PUD Area Plan / Rezoning Review For City of Dexter, Michigan

Applicant:	MMB Equities, LLC – Steve Brouwer
Project Name:	Grandview Commons
Location:	7931 Grand Street (08-06-155-001) 7905 Grand Street (08-06-427-001) Vacant Baker Road (08-06-427-002) 7961 Grand Street (08-08-06-285-004)
Current Zoning:	I-1, Limited Industrial / Village Residential / Baker Road Corridor
Plan Date:	January 27, 2016
Revised Date:	May 6, 2016
Action Requested:	Approval of Area PUD Plan. Approval of an Area Plan shall indicate acceptance of uses, building locations in the case of a PUD of eighty (80) acres or less in area, layout of streets, dwelling unit count and type, floor areas, densities, and all other elements of the area plan. Approval of the Area Plan also allows the applicant to apply for final site plan approval (Section 19.08 D. 3.).
Required Information:	There are two primary components to PUD Area Plan approval. The first is a review and analysis of the “Impact Assessment” as described in Section 19.08 A. 4. f. (2). The second component is the preliminary site plan is outlined in Section 19.08 B. 1. We will note any informational deficiencies in the body of this review.

Re: 8080 Grand St.

TITLE: **ELEVATIONS**

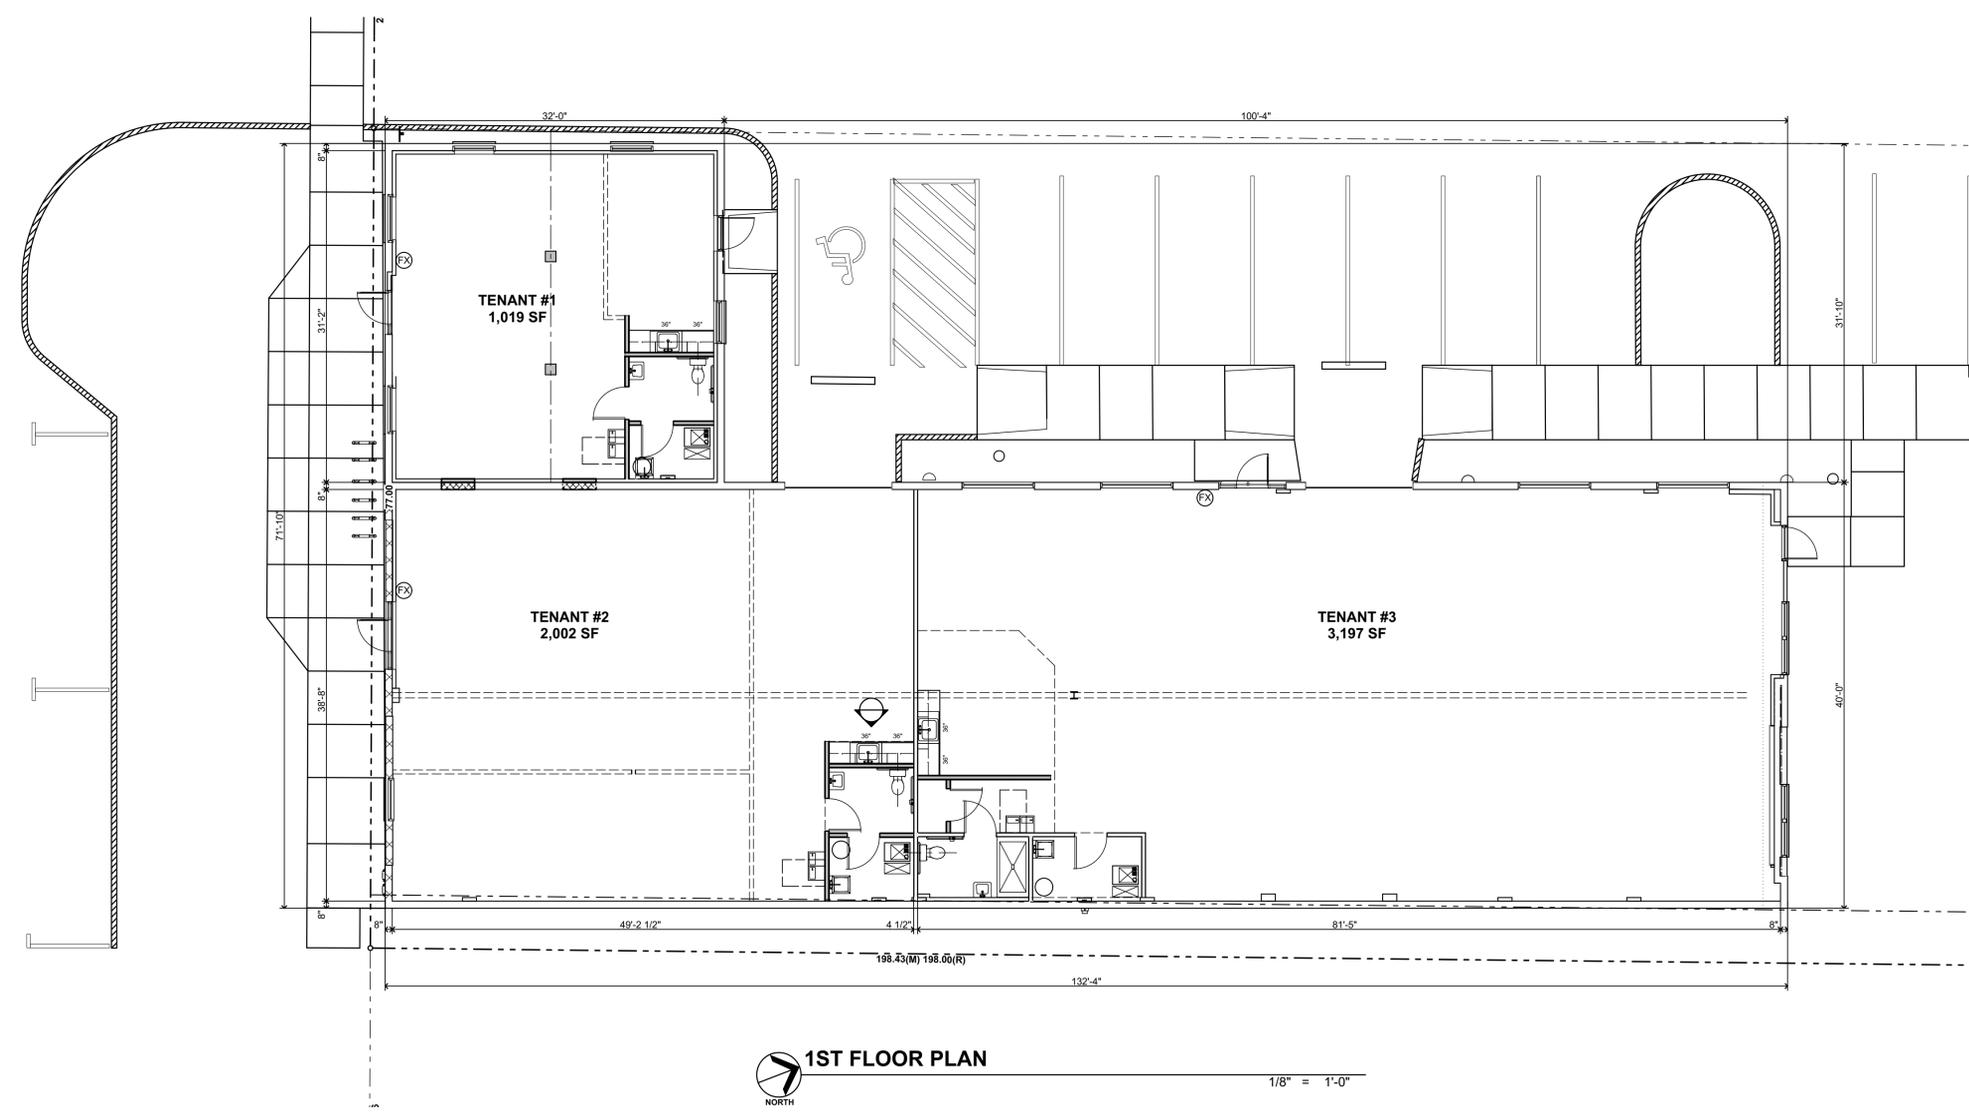
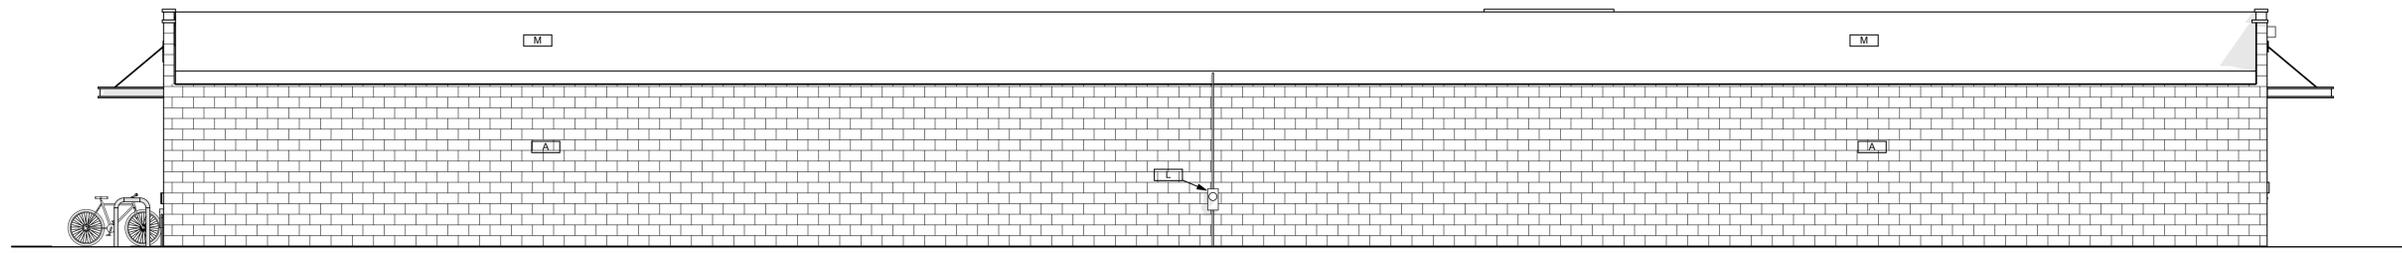
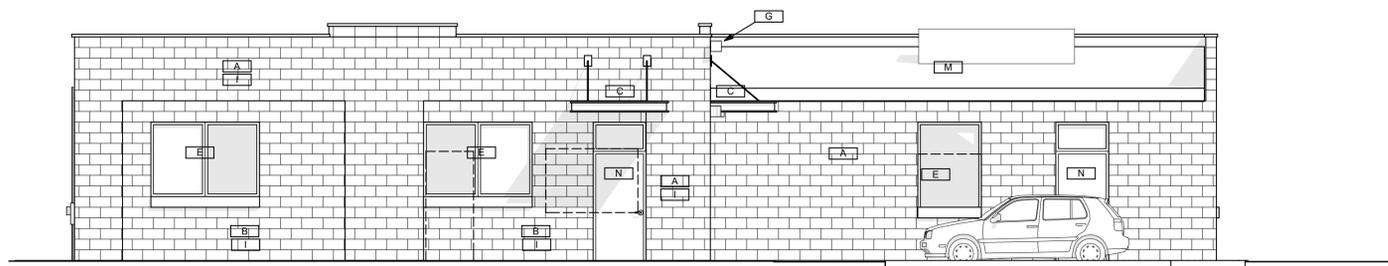
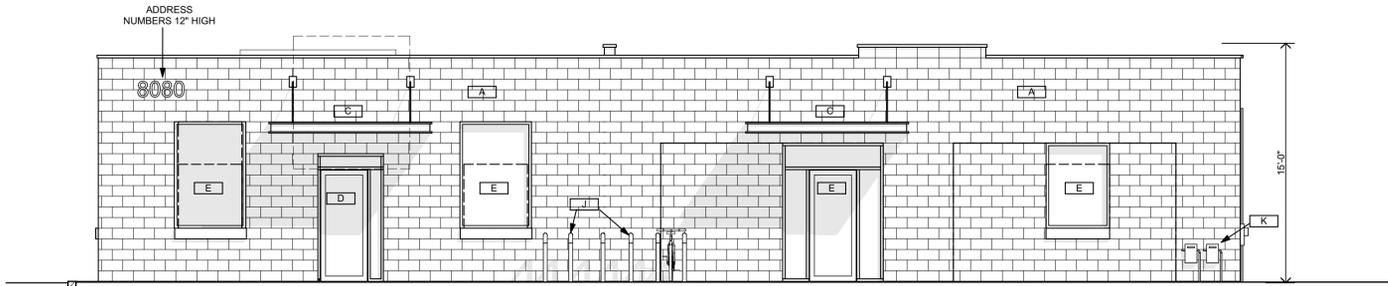
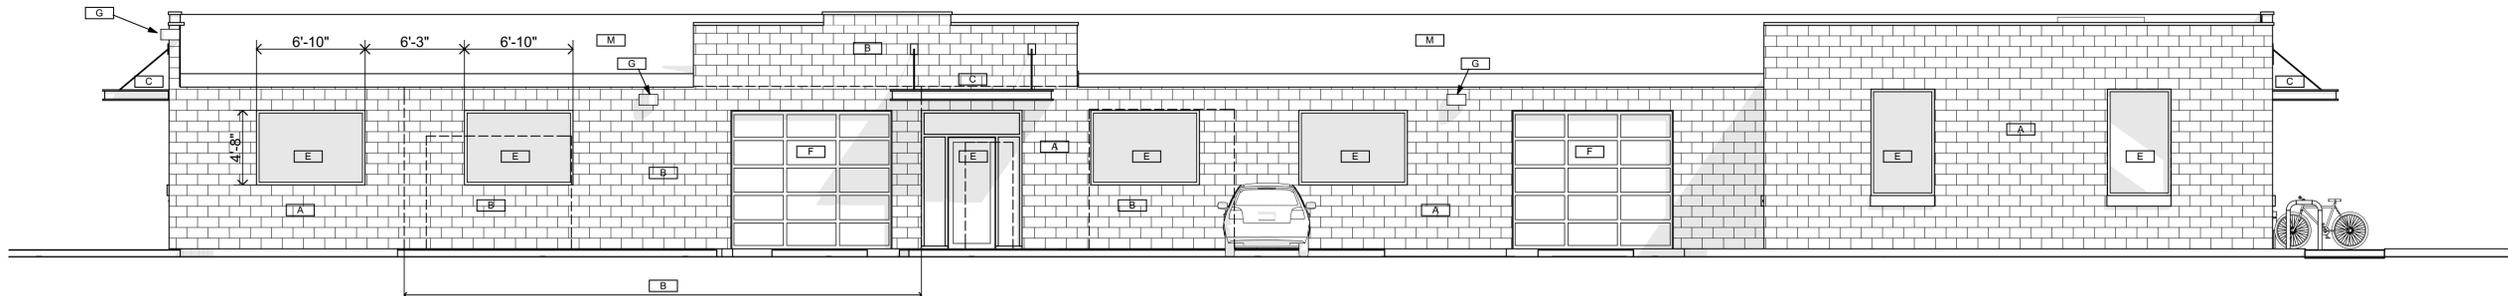
Floor plans as well as all elevations, and a color rendering of the site have been provided. Exterior materials will remain as currently constructed (masonry). We note the west elevation (labeled "left" on Sheet A-2) will maintain two (2) garage bays with overhead doors. The applicant noted the garage bays are an original component of the structure, and will be upgraded to an attractive glass door. There is potential for access for various types of uses; however, auto-related uses are not anticipated.
